CERTIFICATE OF APPROPRIATENESS PLACARD

410 Glenwood Ave

COA-0148-2025

Material and Detail Modifications to Previously-Approved COA

Parking Screen

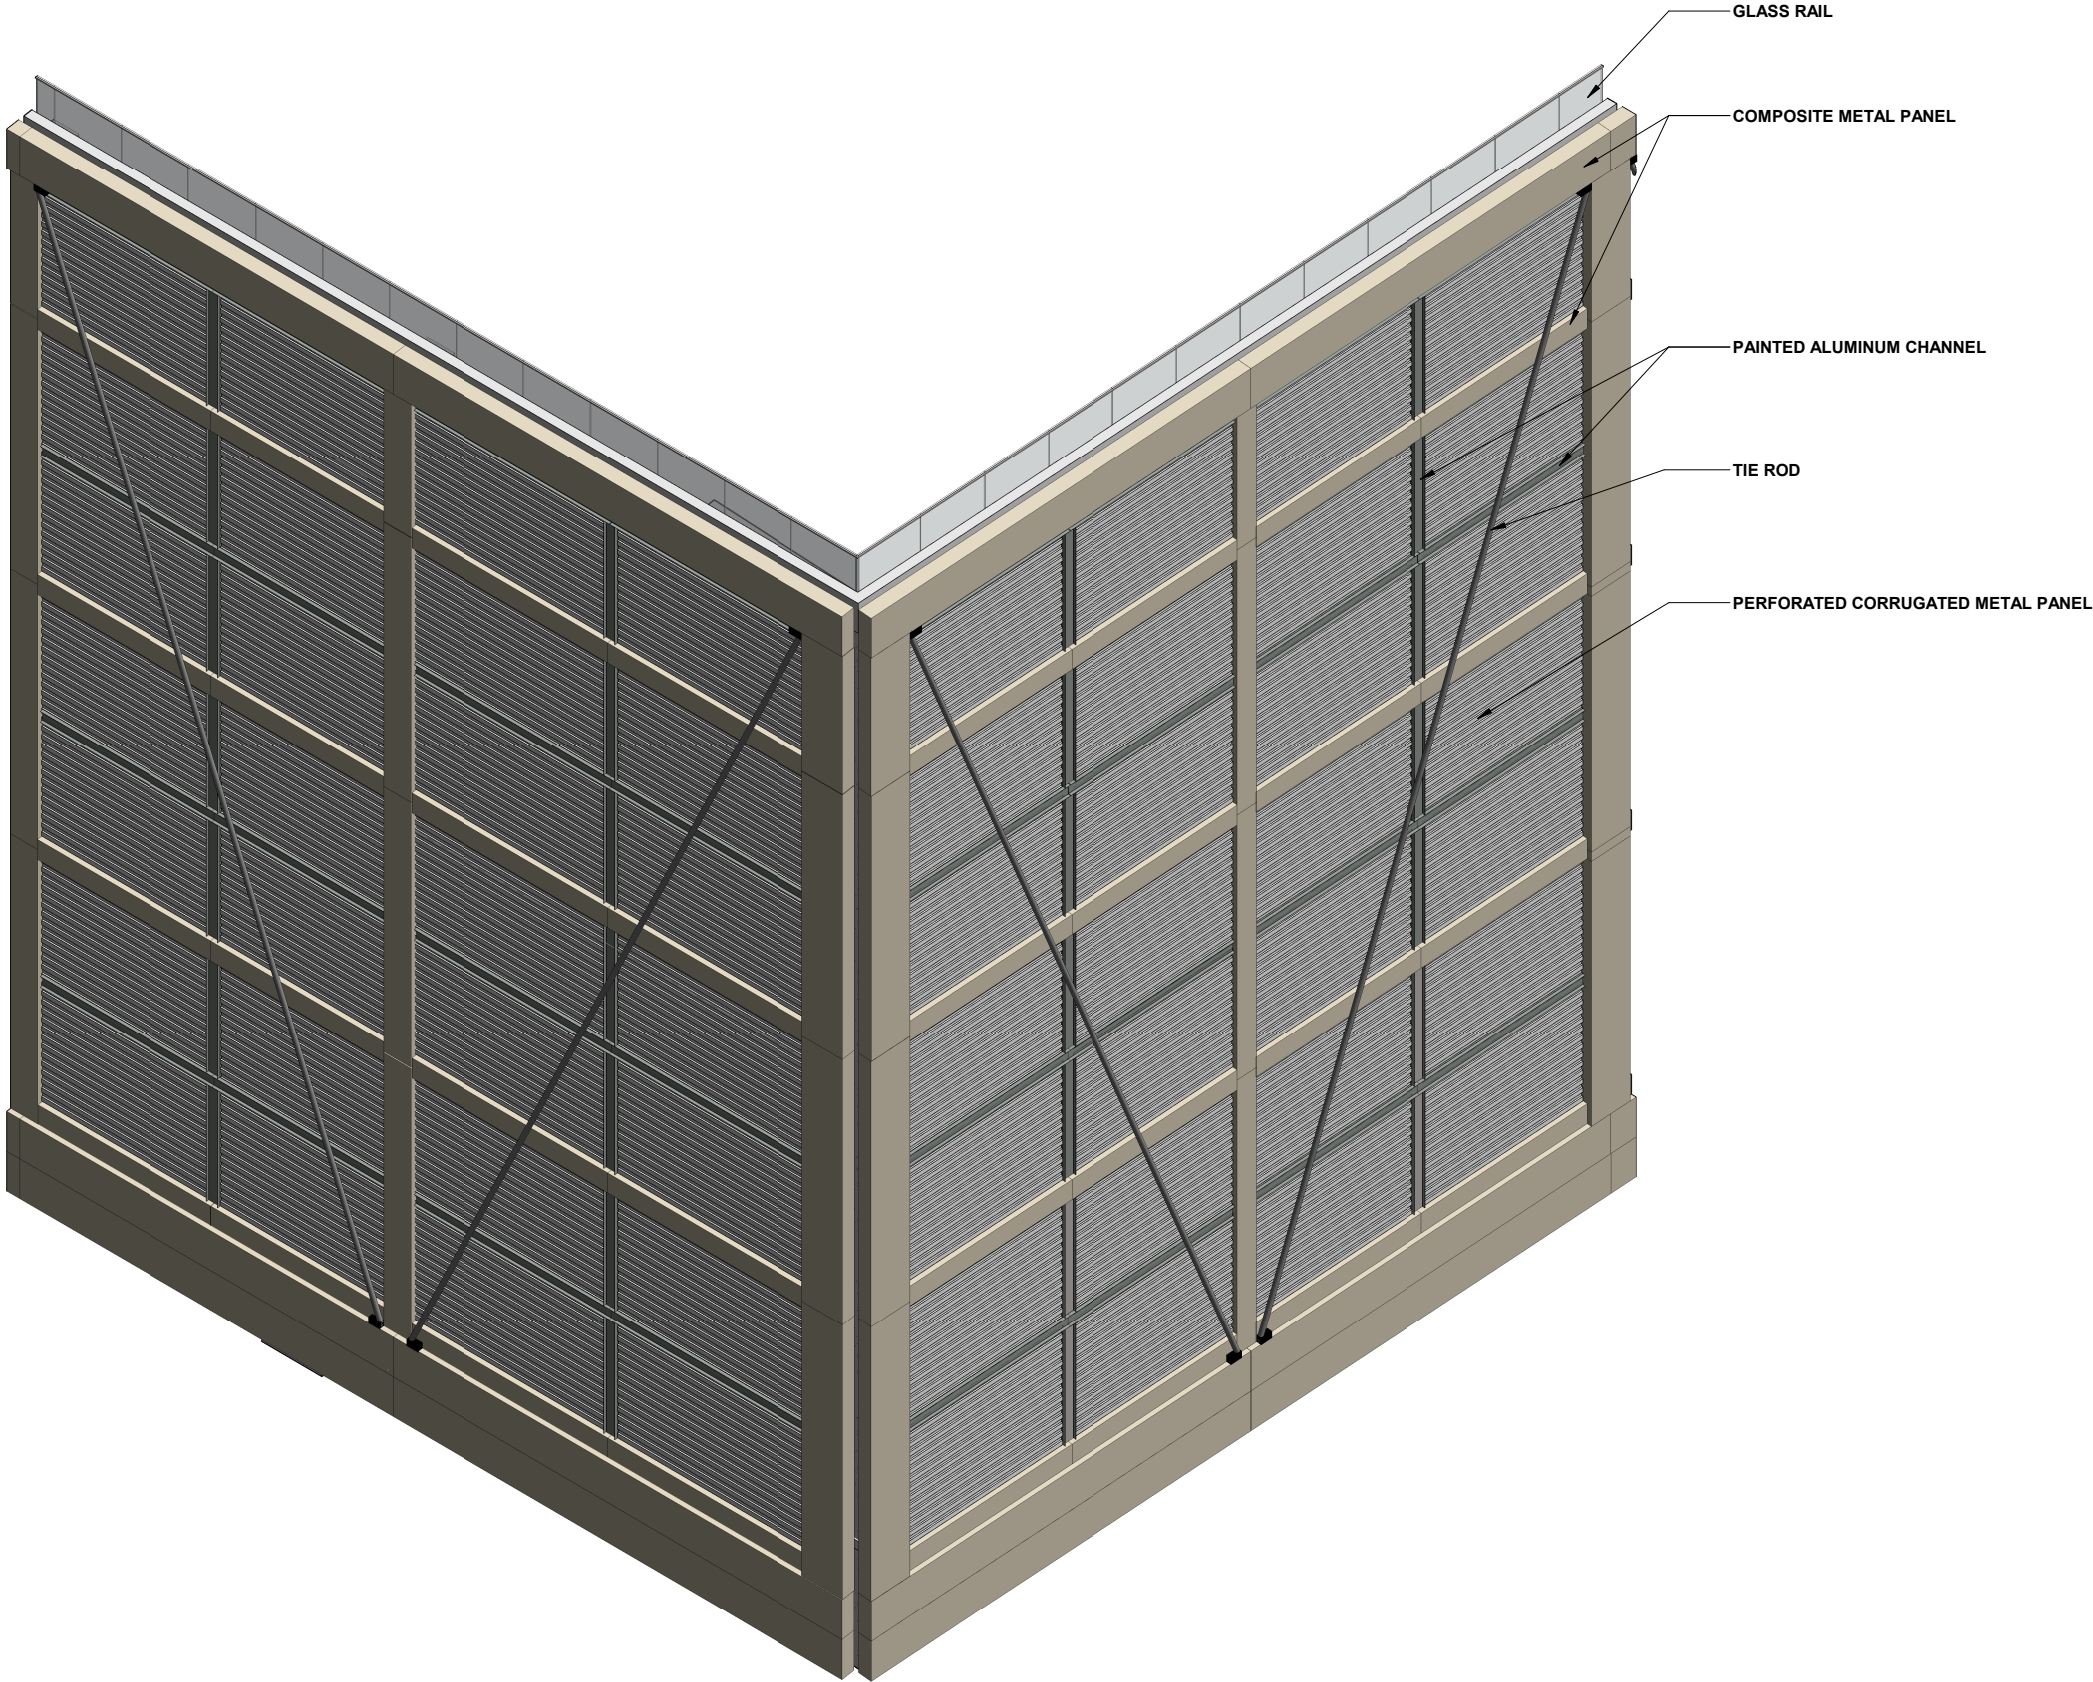
1. The previously-approved elevation included a vehicular garage entry in the east bay, utility/equipment room in the center bay, and a commercial storefront in the west bay. Based on the final engineering for the project, the center and west bays are both required to accommodate equipment and will require overhead door access.
 - The brick and concrete frame and the three associated storefront bay sizes remain consistent with the previously-approved COA.
 - The storefront elevation for these two bays has been revised to include a mix of overhead doors and storefronts in both bays to provide required service access while maintaining an equivalent amount of glazing as shown in the previously-approved COA.

1. The industrial grid has been revised from precast concrete to painted metal panel. As shown in the comparative elevations for the previously-approved and currently proposed elevations, the overall massing, dimensions, and color range of the industrial grid will be generally consistent with the previously-approved COA:
 - The rectangular profiles and widths of the grids (3'-0" for primary and 1'-6" for secondary) match the previously-approved design.
 - Due to manufacturing limitations, the proposed depth of the frame decreases from 12" to 10".
 - The 3" diameter tie rod is visually consistent with the previously-approved COA.
2. The mesh screening has been revised from expanded metal to perforated corrugated metal:
 - The level of transparency is generally consistent with the previously-approved COA.
 - The color is consistent with the previously-approved COA.

1. Side-by-side rendered elevations for the previously-approved and currently proposed elevations + enlarged elevations illustrate these modifications. *Note that the proposed elevations represent the reduction in height as approved per COA-0018-2025.*

ENLARGED SOUTH ELEVATION - PARKING ENTRY / EXIT 1
3/8" = 1'-0"

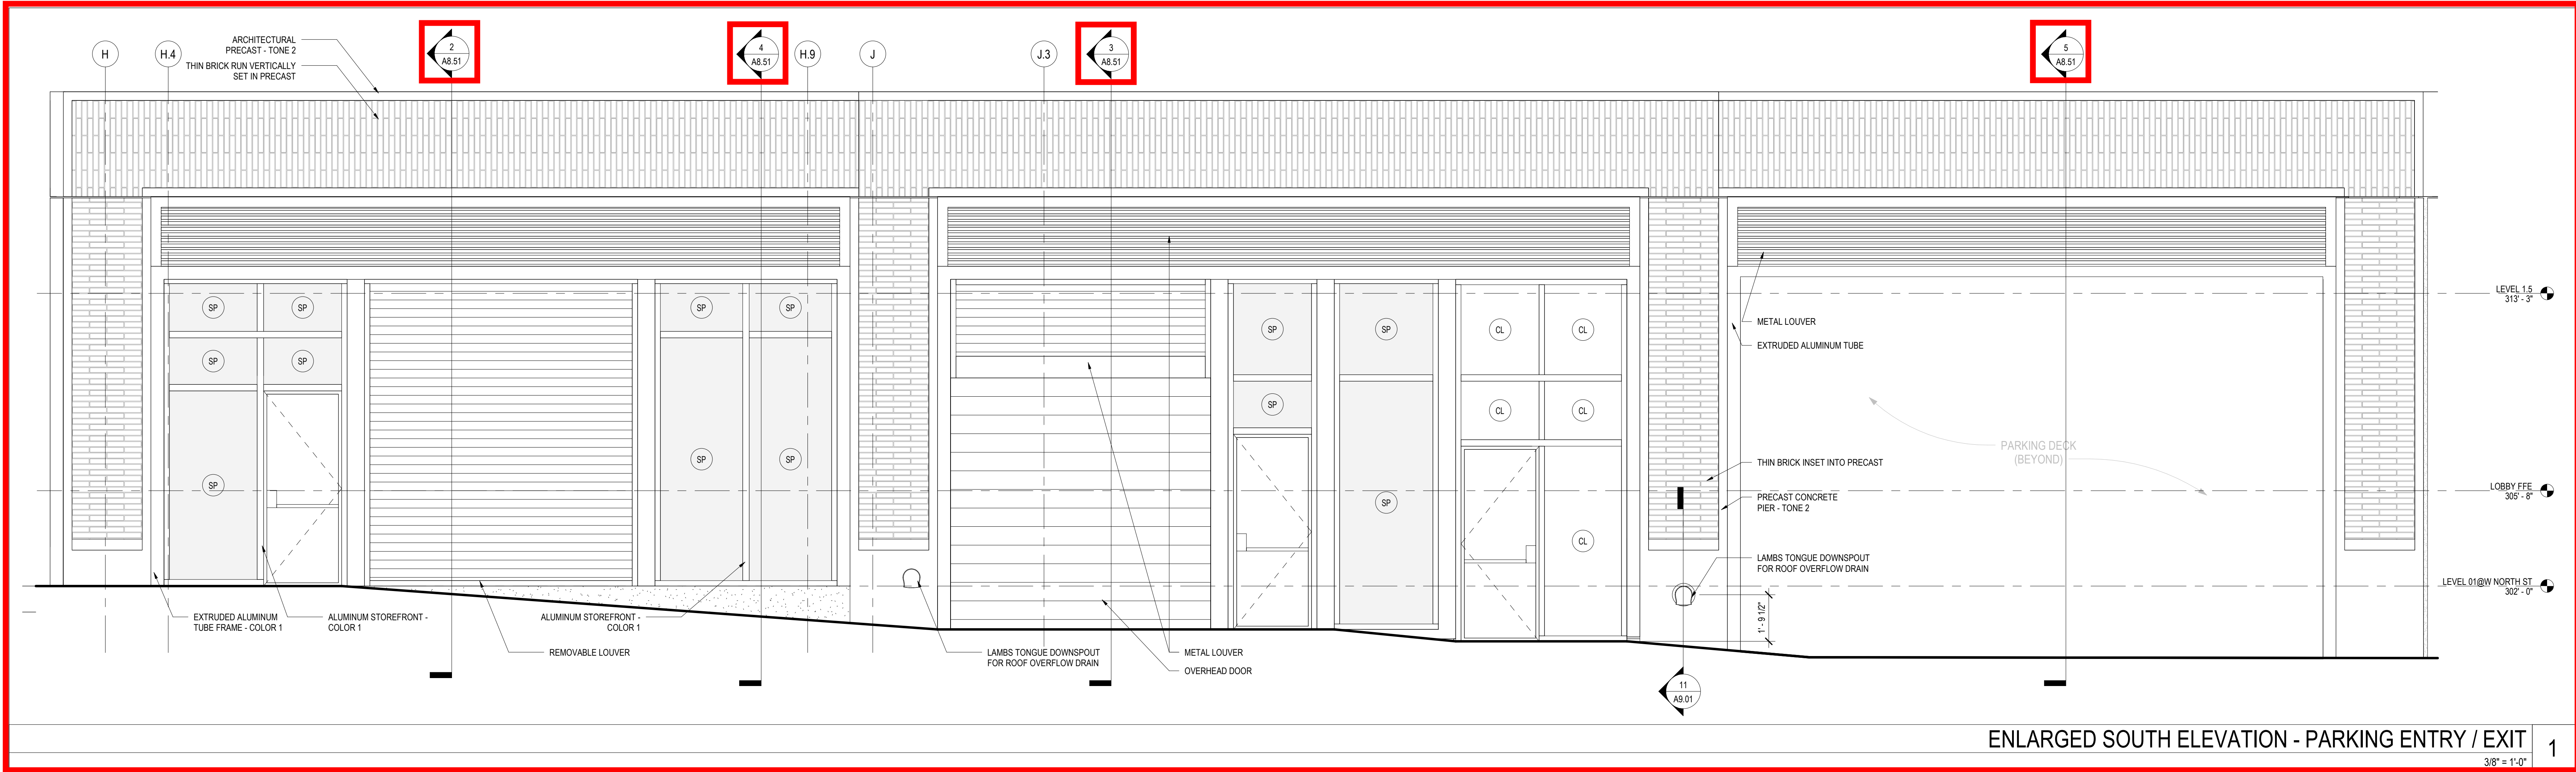
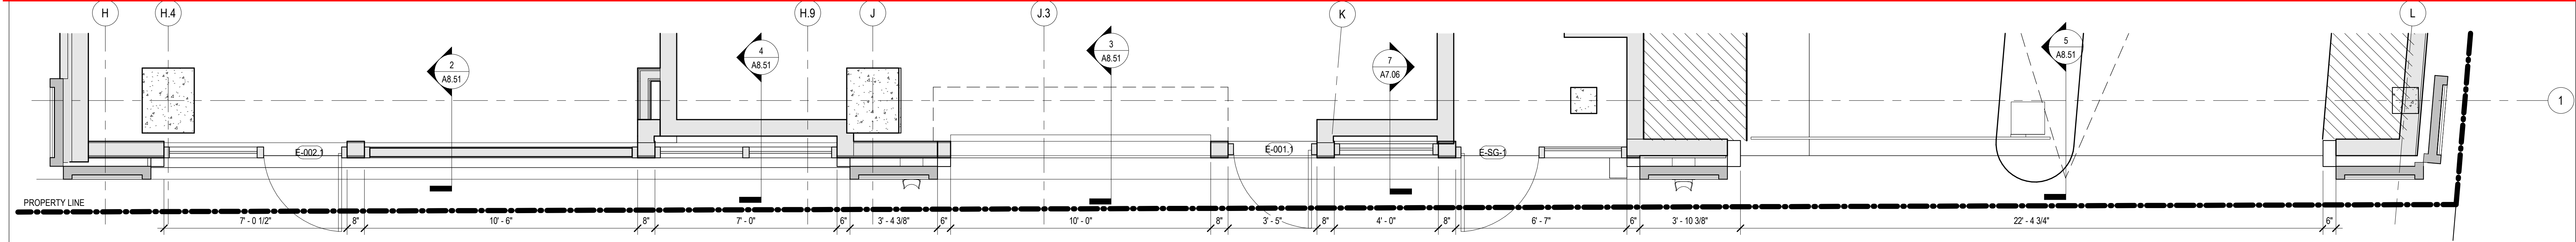
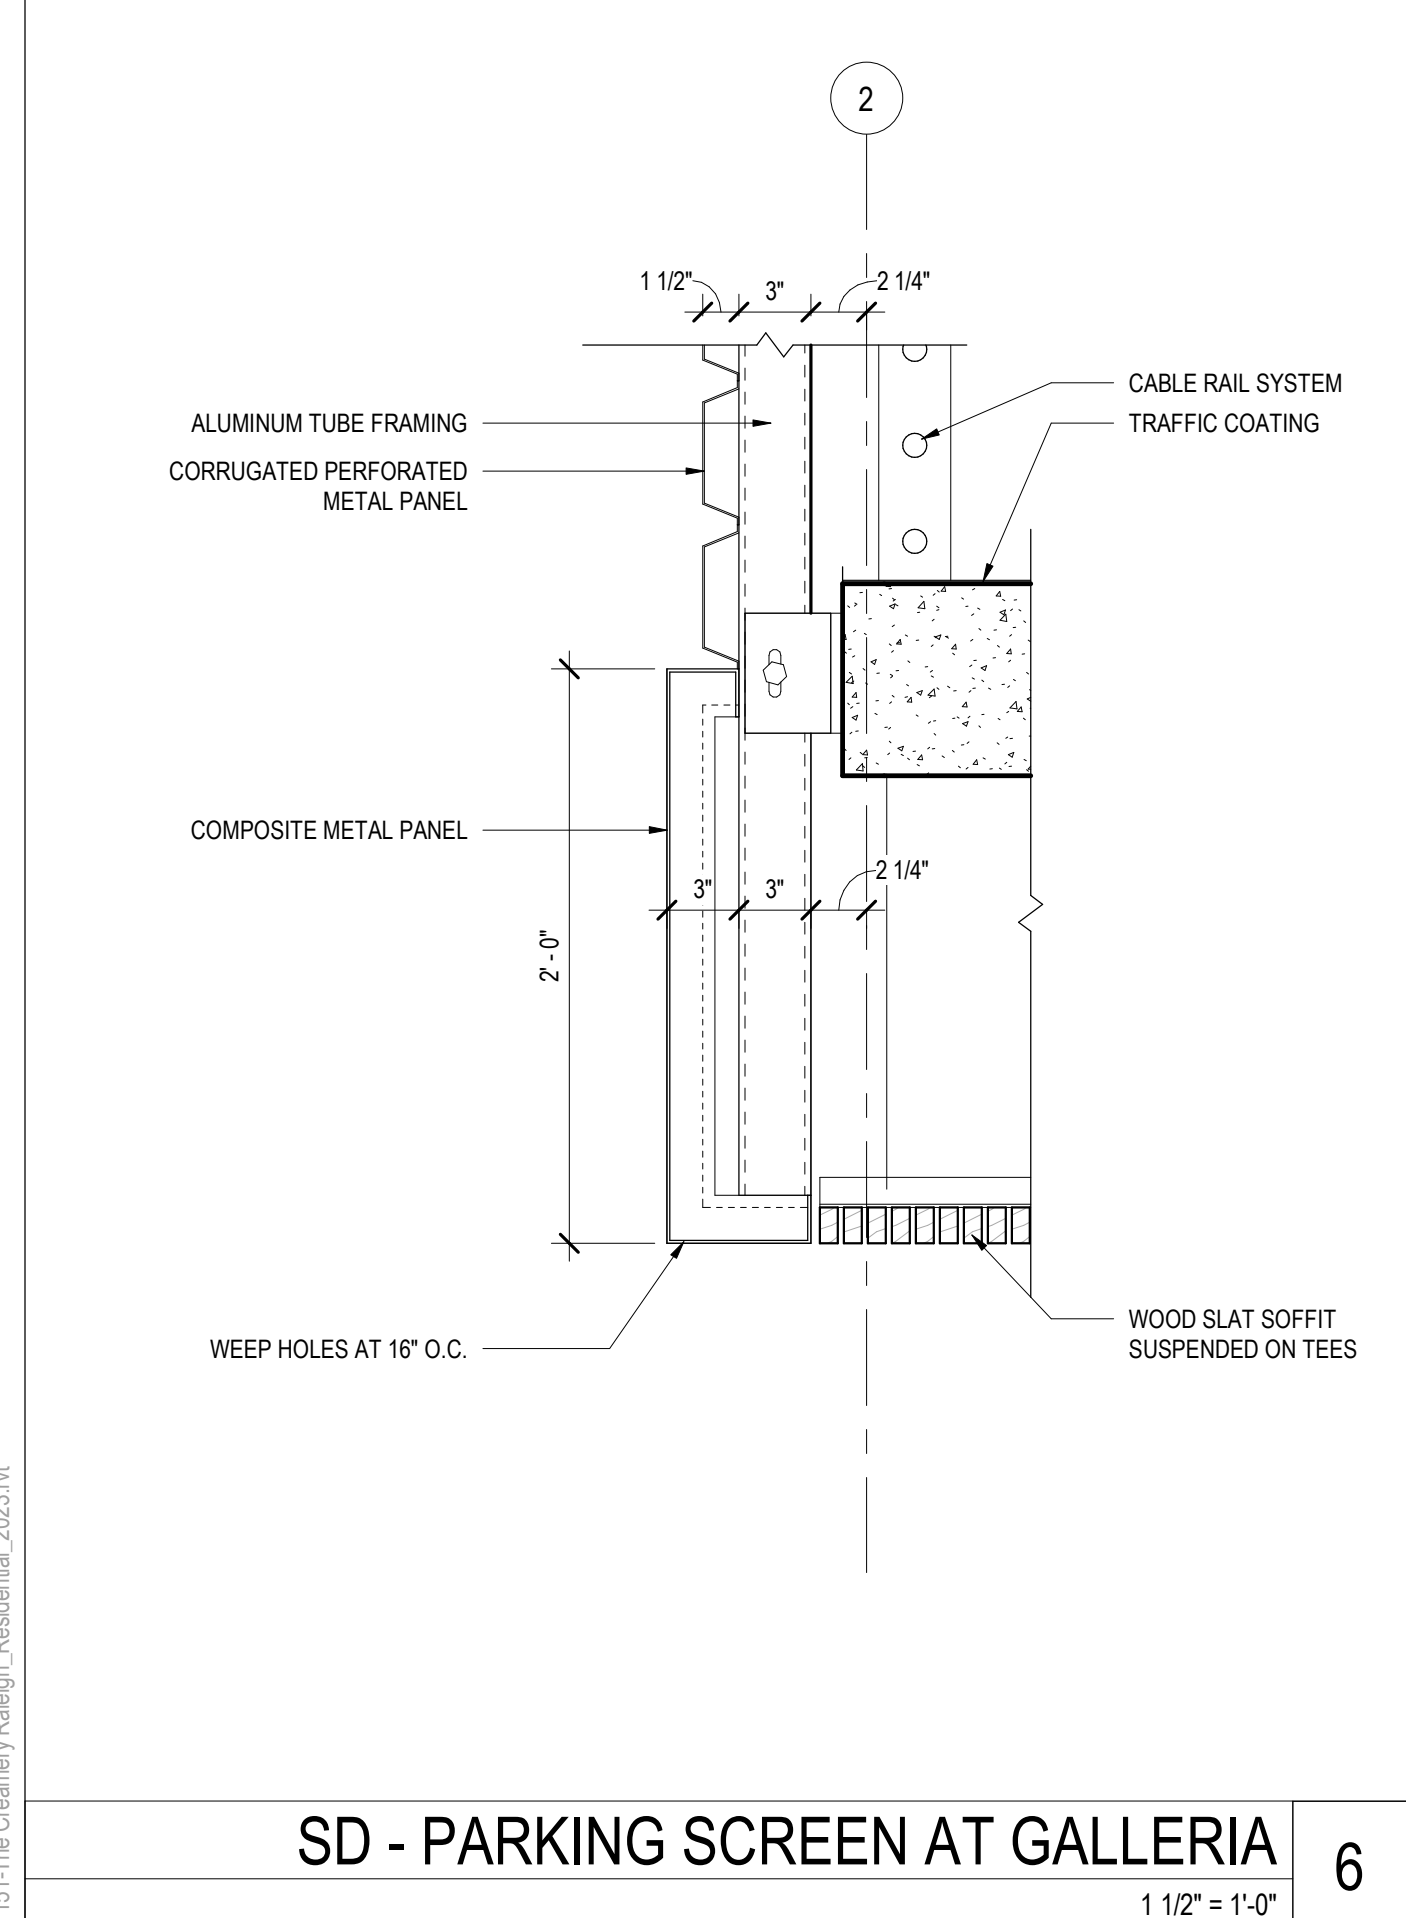
3. Architectural drawing 1/A3.91 illustrates the street level storefront at the South Elevation (North St). Architectural drawings 2, 3, 4, and 5/A8.51 illustrate the wall sections through the storefront and overhead doors + door schedule A11.02 confirms door sizes per Condition #4 of the December 09, 2021 Decision Letter.
